# 1993 Corvette: Service Bulletin: Hood Will Not Open - Cable Disconnection

**Subject:** HOOD WILL NOT OPEN, CABLE DISCONNECTED

**Bulletin Number:** 93-151-10

TOOL

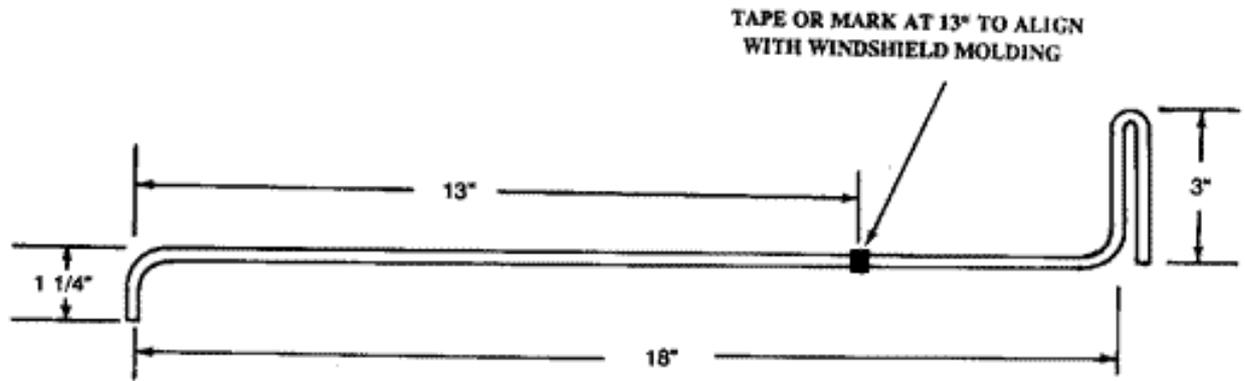
The hood release cable may become disengaged from the hood latch lever.

**NOTE: It is possible that one or both of the latches may have disengaged cables.**

Replace the hood latches with service P/N's 10210747 (Left) and 10210748 (Right)

- Obtain material locally and fabricate the tool shown on the illustration from 3/16" or 1/4" steel rod.
- With the door open, locate the short bent end of the tool inboard of the vertical flange of the hood latch support.
- insert the tool forward until the tape is aligned with the lower end of the windshield pillar molding.
- Twist the tool to contact and move the latch lever until the latch disengages. A slight downward pressure on the hood in the latch area may be helpful to disengage the latch lever.

TOOL IN POSITION  
(DOOR REMOVED FOR ILLUSTRATIVE PURPOSES)

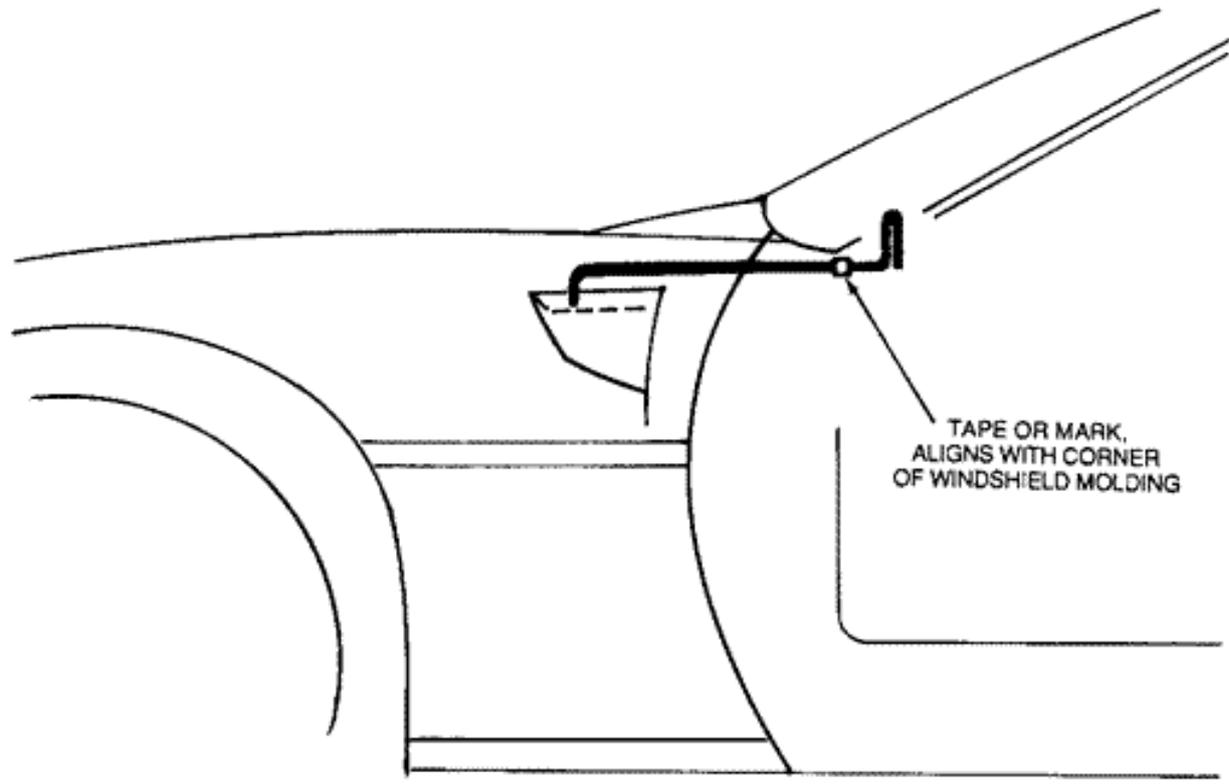
**NOTE: Opening the hood will require the following:**
